# CHANGE ORDER

Project Name: **Stoughton Fire Station No. 1** CO No. **05r**  
400 Prospect Street

Architect's Project No. **19-0796**

## Change Order No. 05

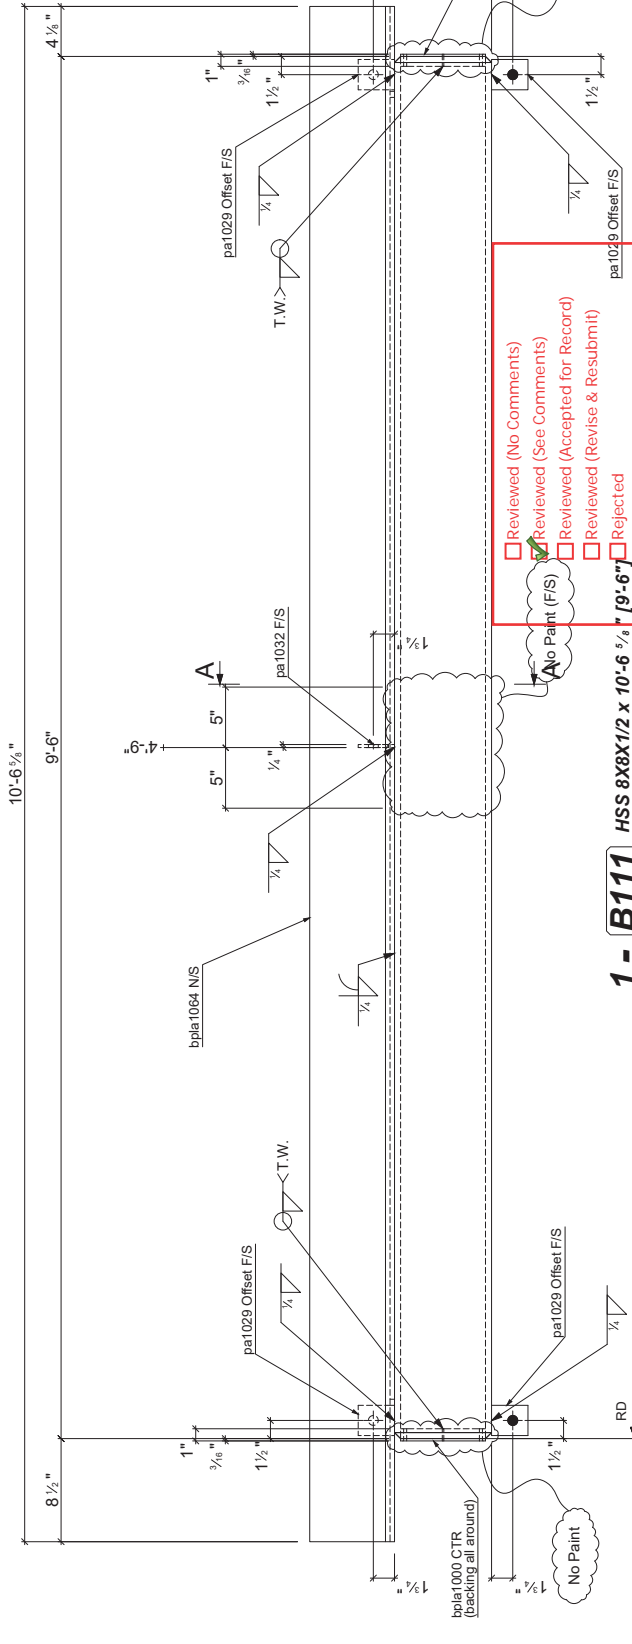
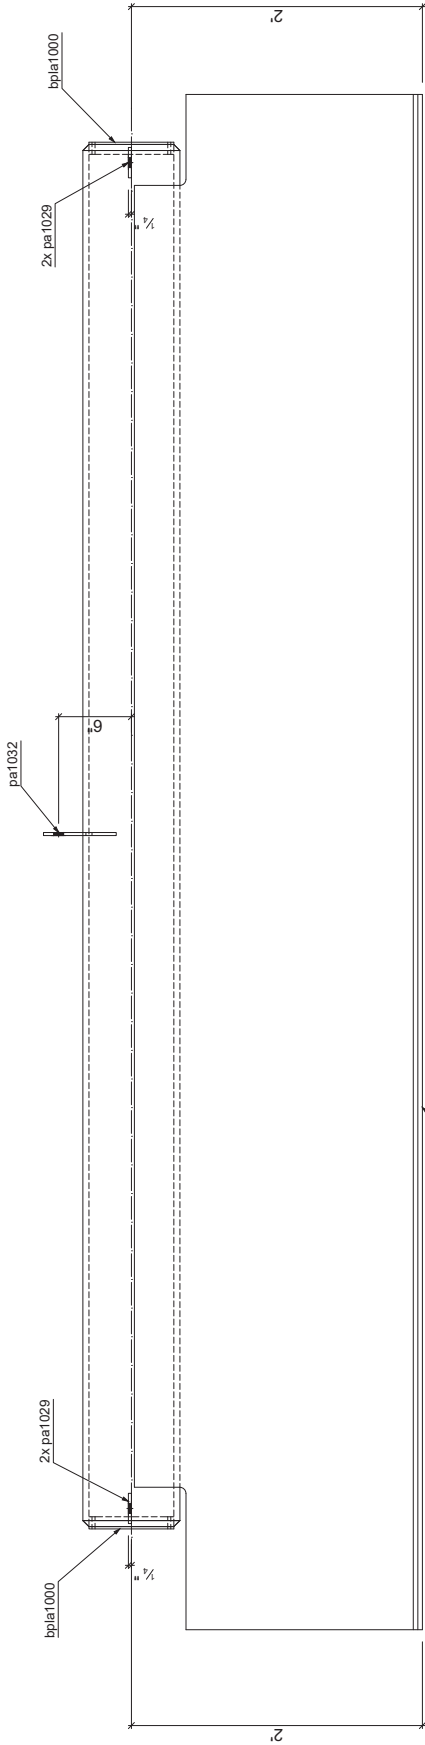
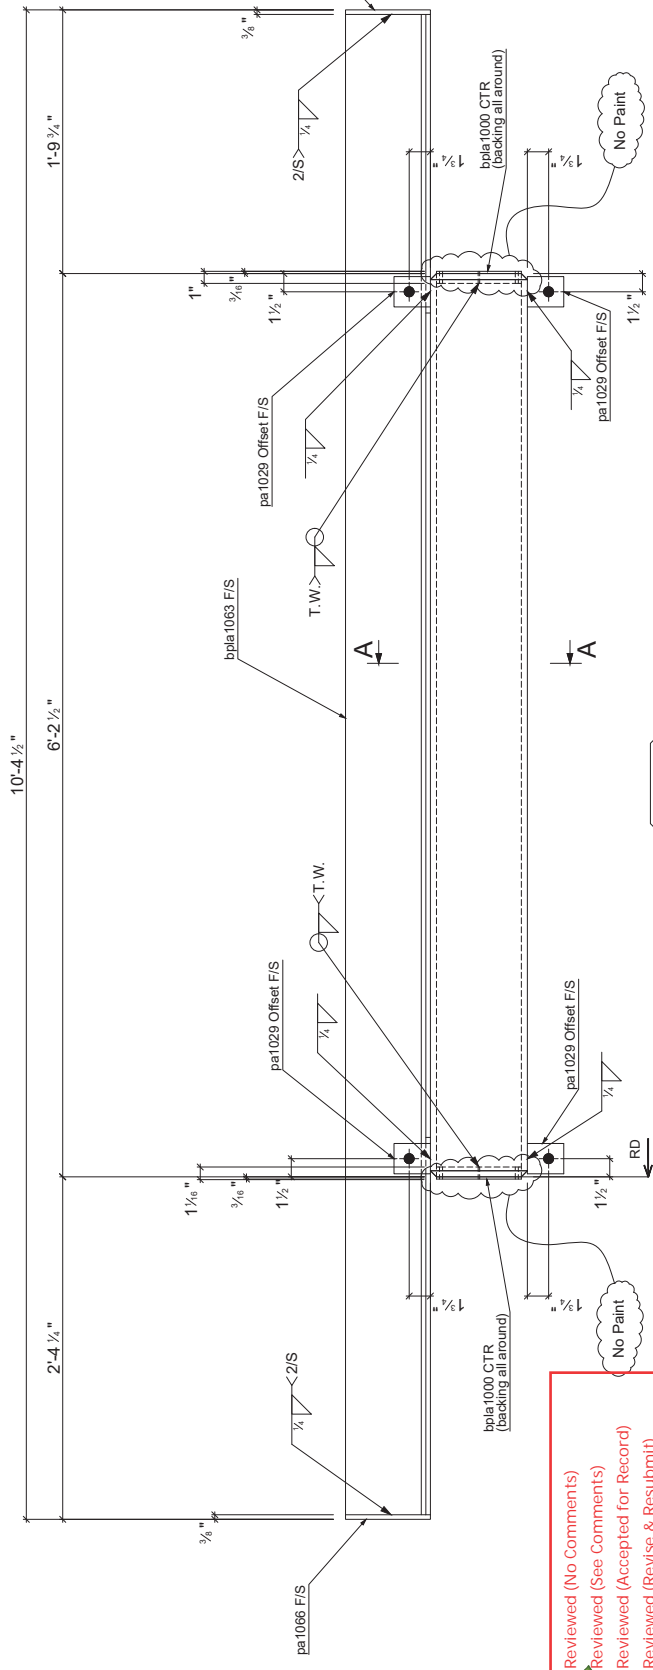
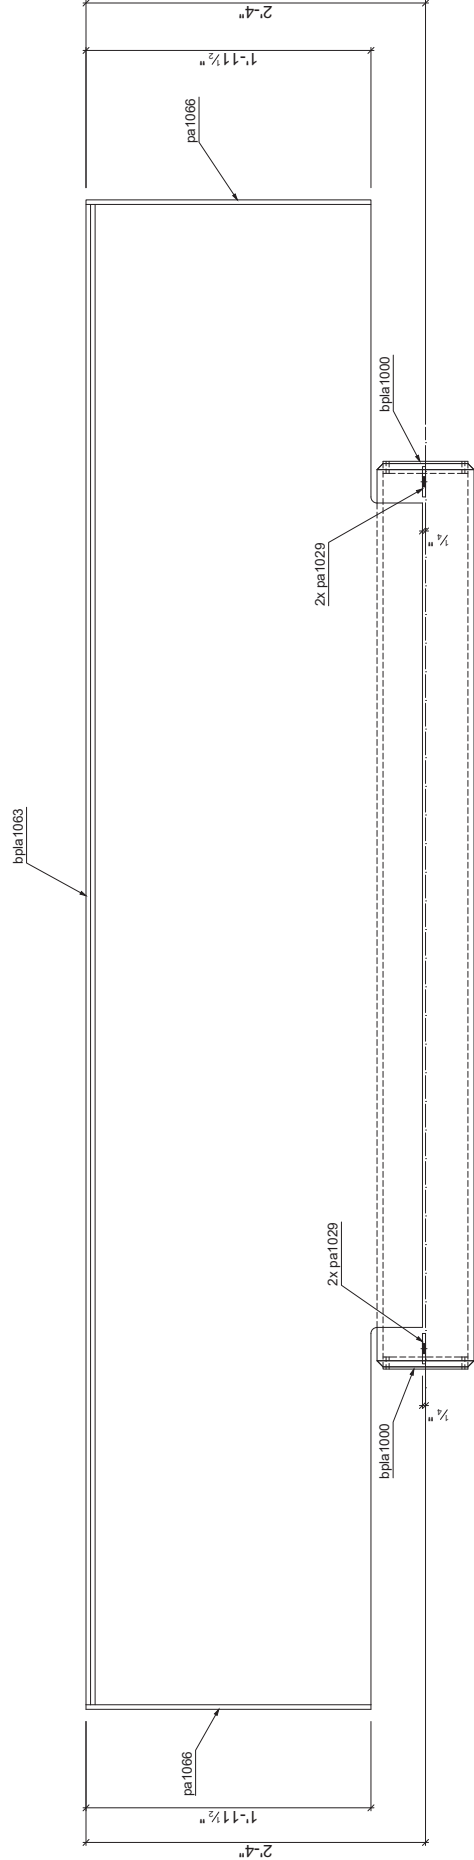
EDC-N:MASFIKAH  
 PROVIDE GALVANIZED STIFFENER PLATE AT THE EDGE  
 OF THE CANOPY TO SUPPORT THE SLAB EXTENSION

1 JD 38 LEVEL 2 FLOOR PLAN - POWER  
 JD 38 SCALE: 1/8" = 1'-0"

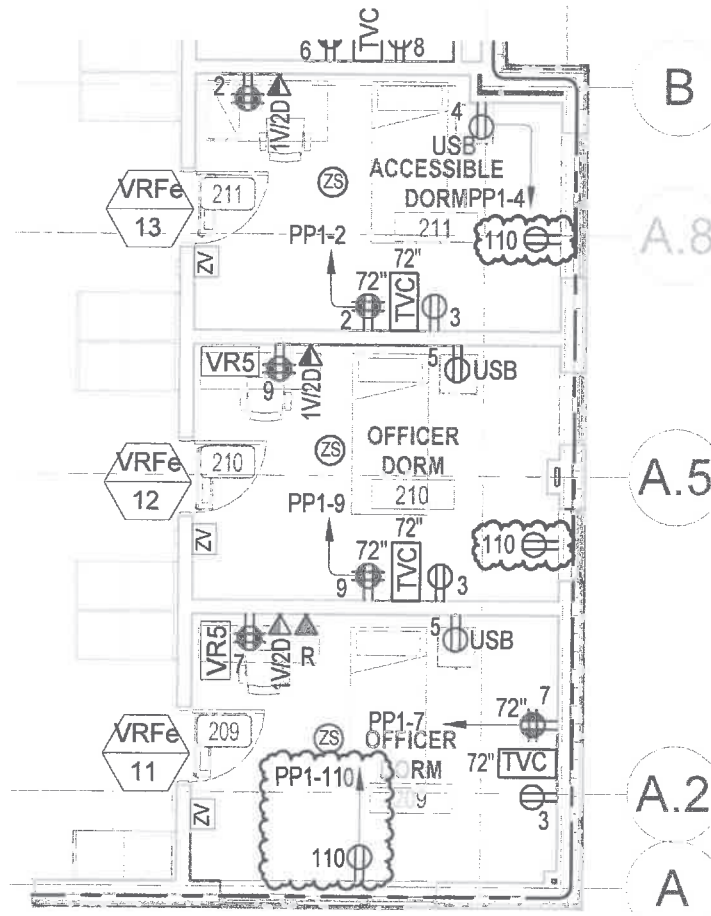
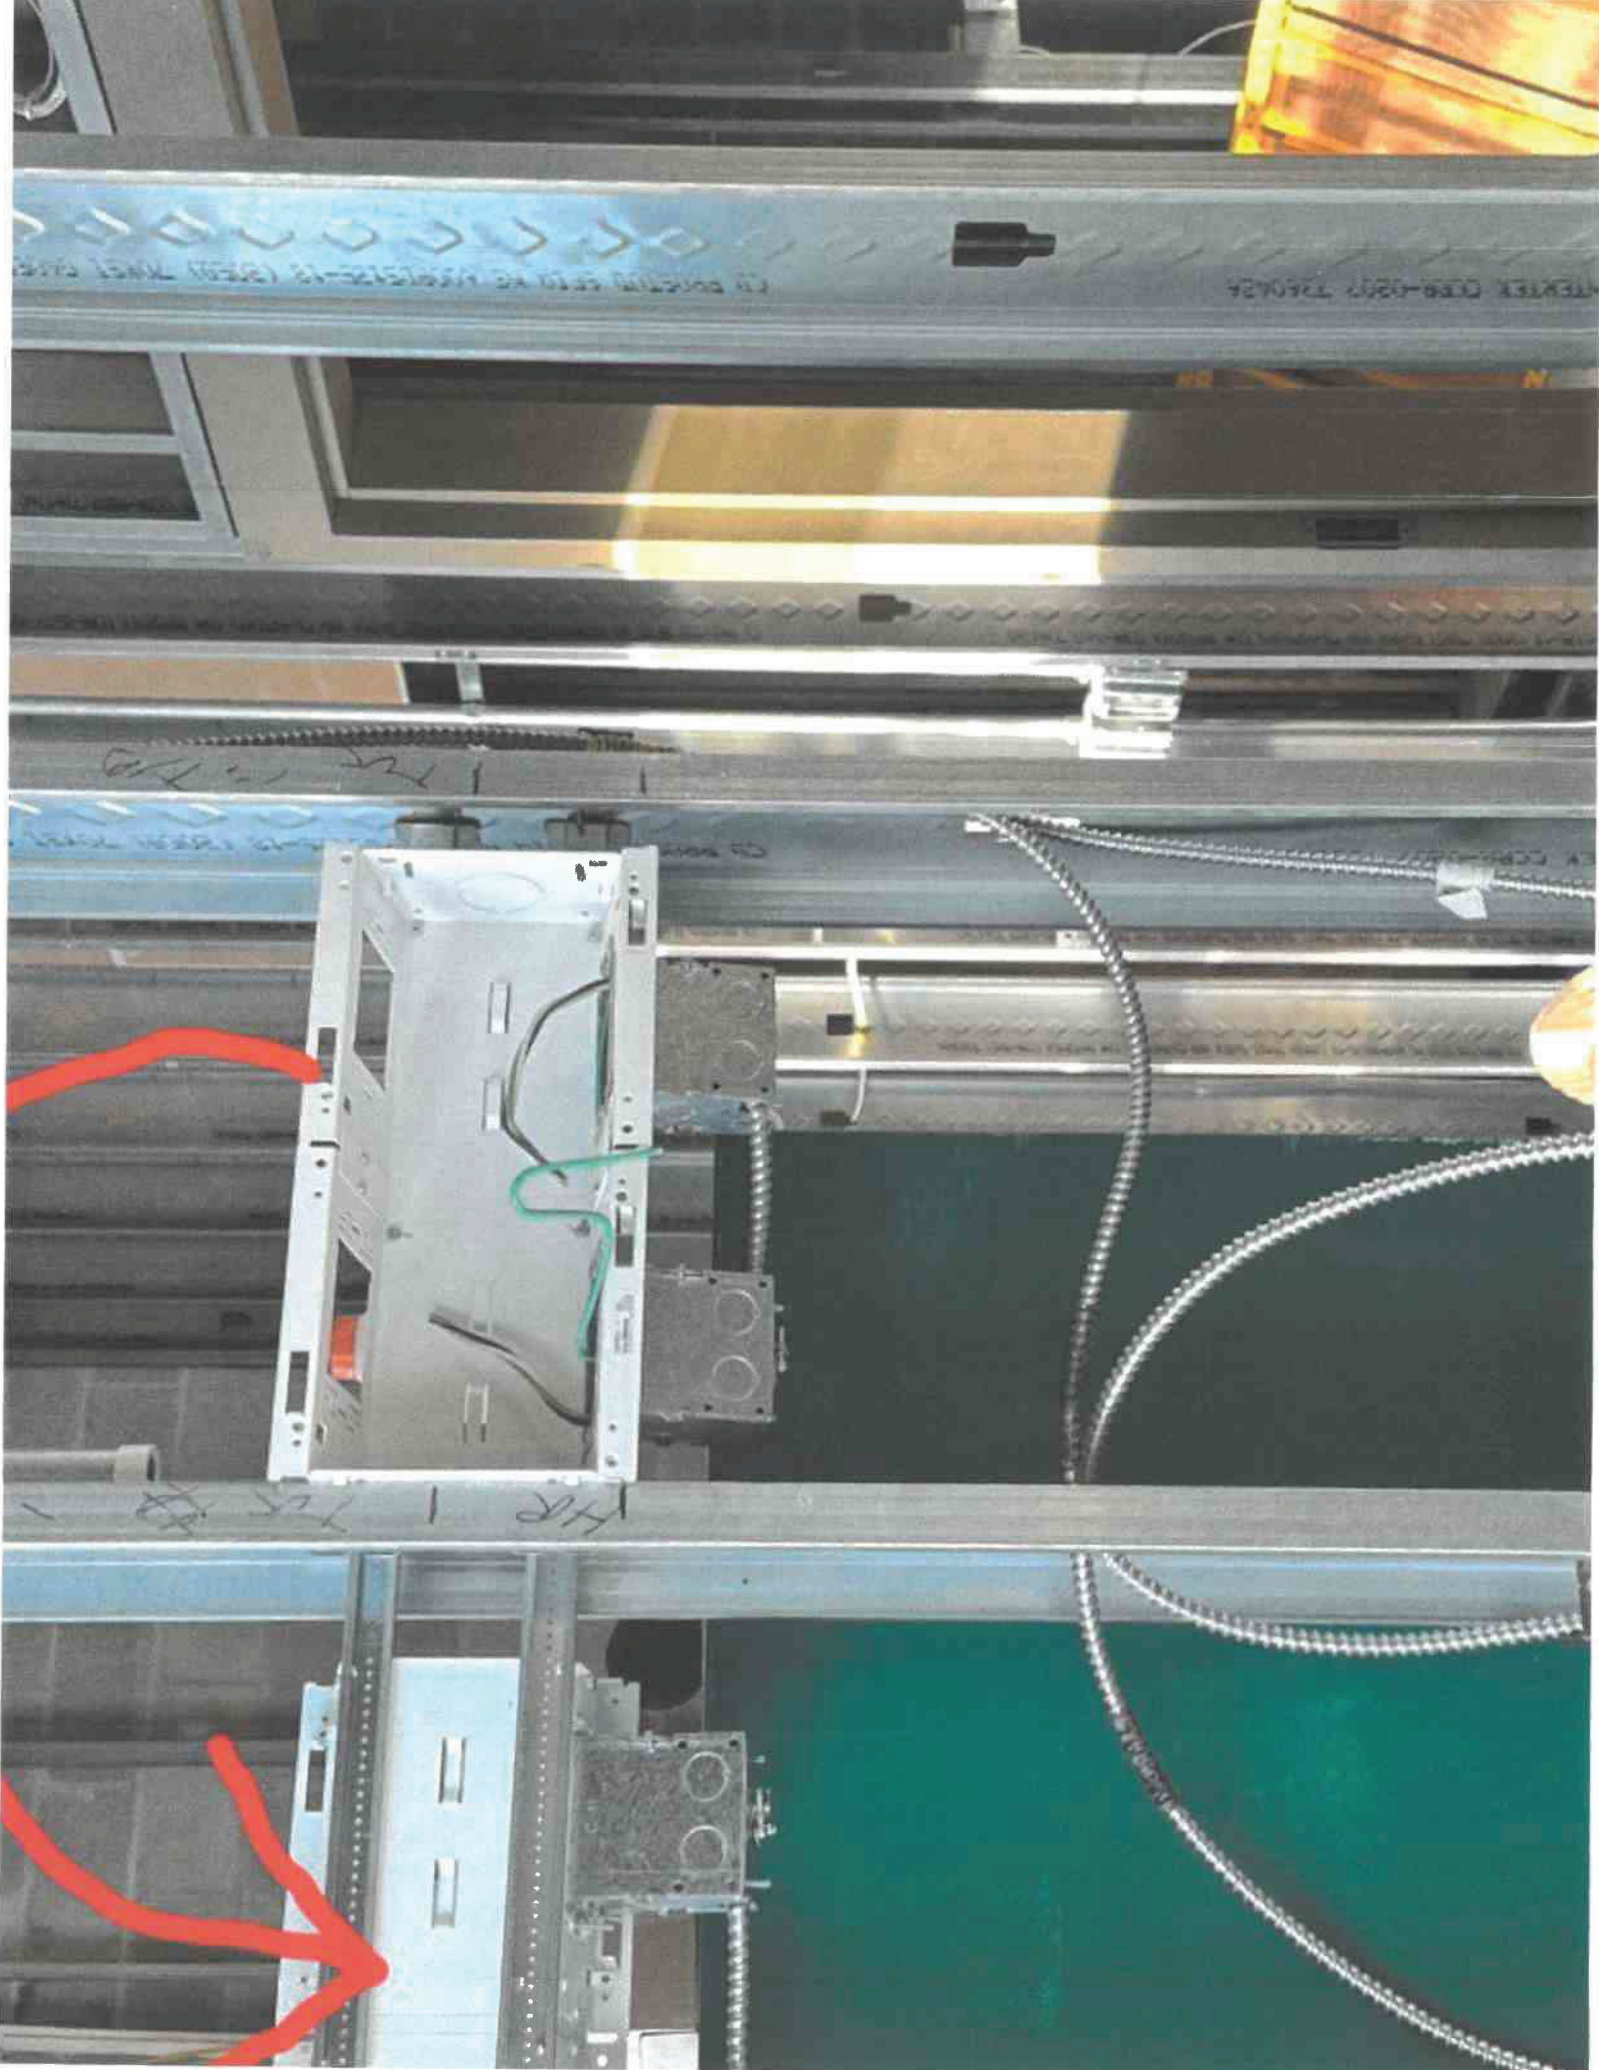
Provide a cost proposal for the addition of 3 duplex outlets shown in the attached JD 38. Alongside, within Dorm Room 208 move the Video Display Outlet over one bay if possible, as shown in attached image, back to back with outlet already installed in Dorm Room 207. Otherwise relocate Video outlet box in Dorm Room 207 up half outlet height so Dorm room 208 Video outlet can be placed below.

A17 3" = 1'-0"

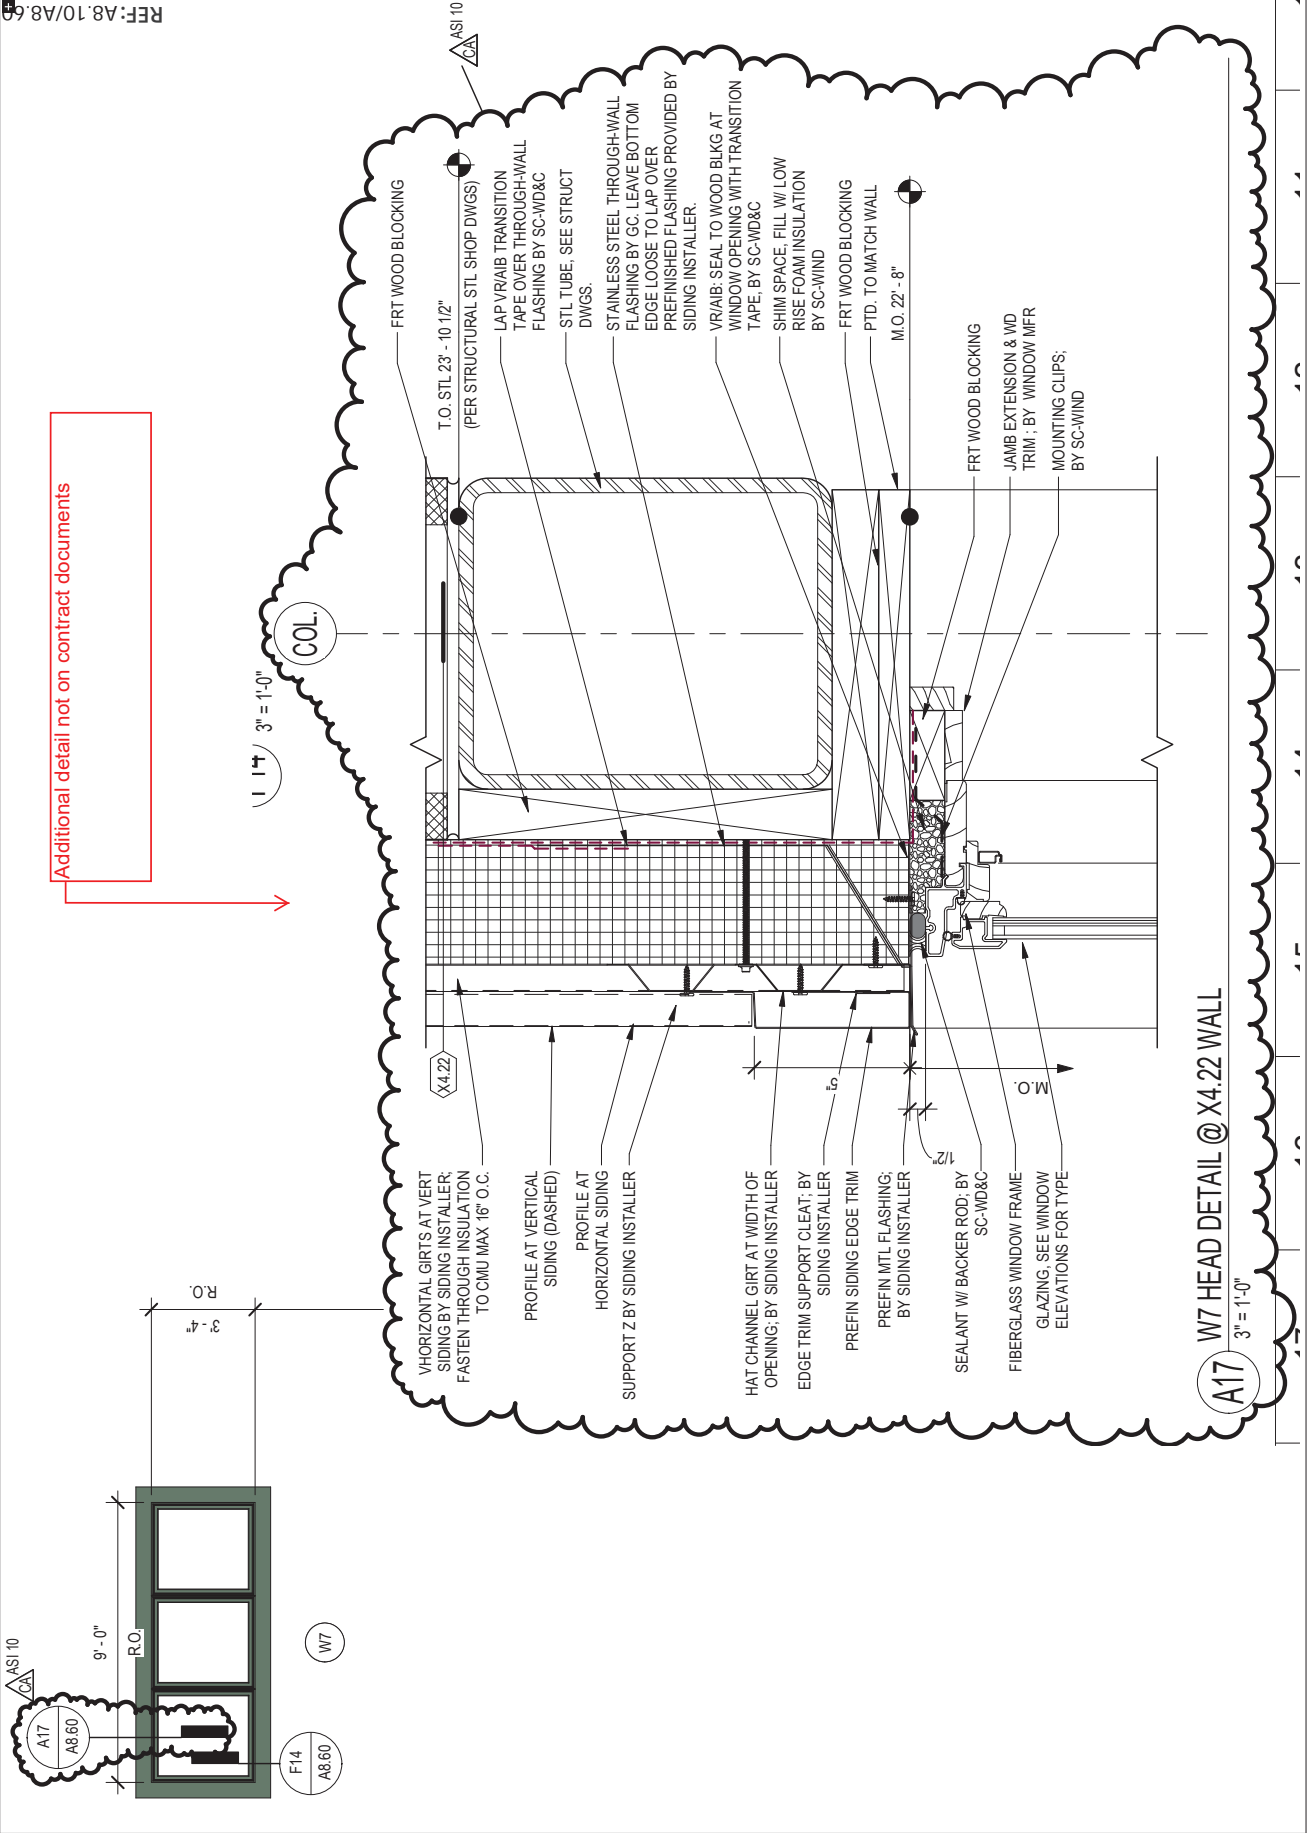
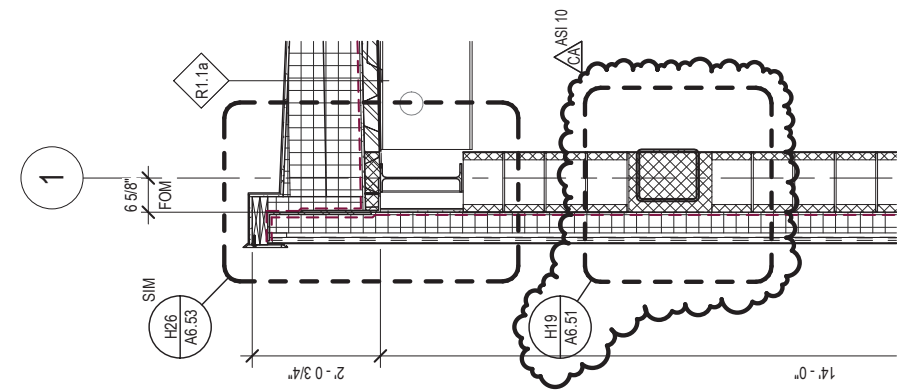
- At sheet A6.10, detail A4, revise wall section per JD40
- At sheet A6.51, add detail H19 – MID OF WALL DTL - @ X4.22 WALL TYPE & HORIZ BEAM, per JD40
- At sheet A8.10, window types legend, Type W7, revise Call out per JD39
- At sheet A8.60, add detail A17 – W7 HEAD DETAIL @ X4.22 WALL

Additional detail not on contract documents
